Permit amendment

T-13438

REFERENCE: Permit Amendment Application T-13438

In the Matter of Permit Amendment	)	FINAL ORDER APPROVING
T-13438, Lane County	)	A CHANGE IN
	)	POINT OF APPROPRIATION

: water rights area
Permit: G-18365
Priority Date: 3-27-2019
Irrigation

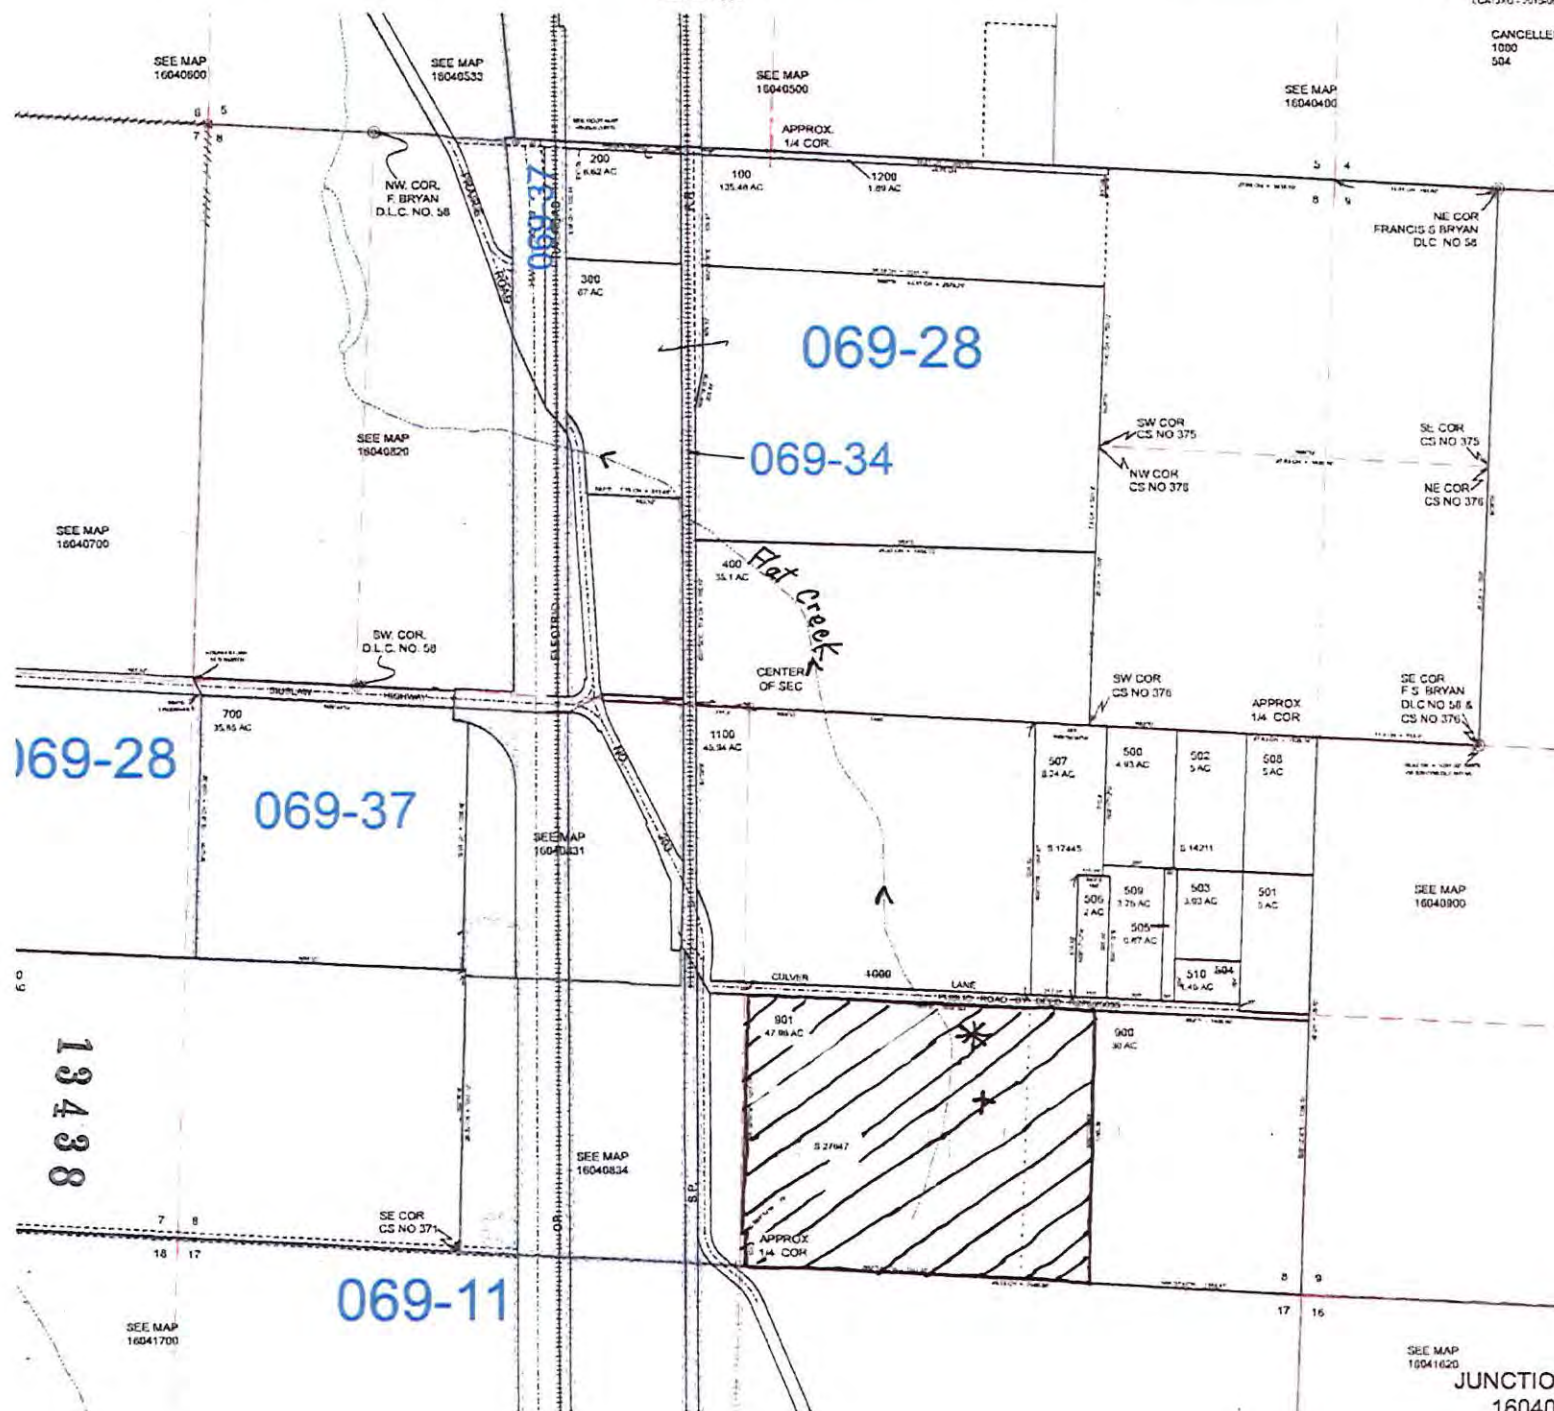
* : Existing well
1150 ft. North + 1580 ft.
W of SE corner of Sec. 8

+ : Proposed well
